**EDEN WATERWORKS COMPANY**  
**KAMMEYER WELL HOUSE, CHLORINATION BLDG.**  
**WELL HOUSE ELEVATIONS**  
**EDEN, WEBER COUNTY, UTAH**

**EDEN WATERWORKS COMPANY**  
**KAMMEYER WELL HOUSE, CHLORINATION BLDG.**  
**WELL HOUSE ELEVATIONS**  
**EDEN, WEBER COUNTY, UTAH**

C4

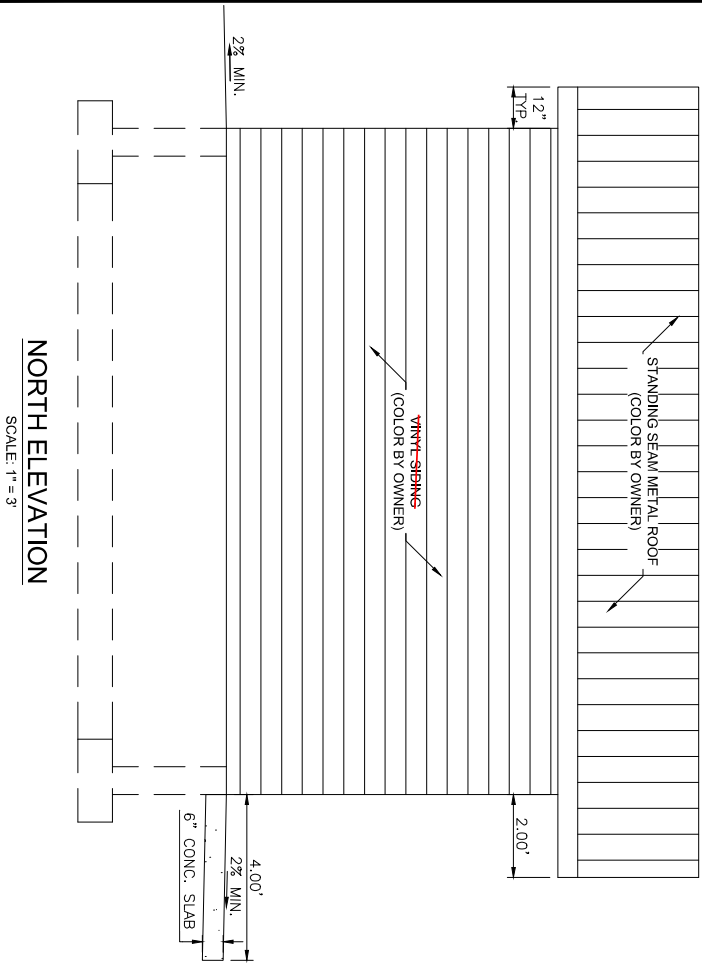
Add a note indicating that the aluminum, metal will be painted and earthtone.

Include a note stating that the recessed lighting will be in compliance with Section 106-16 (Open Valley Outdoor Lighting).
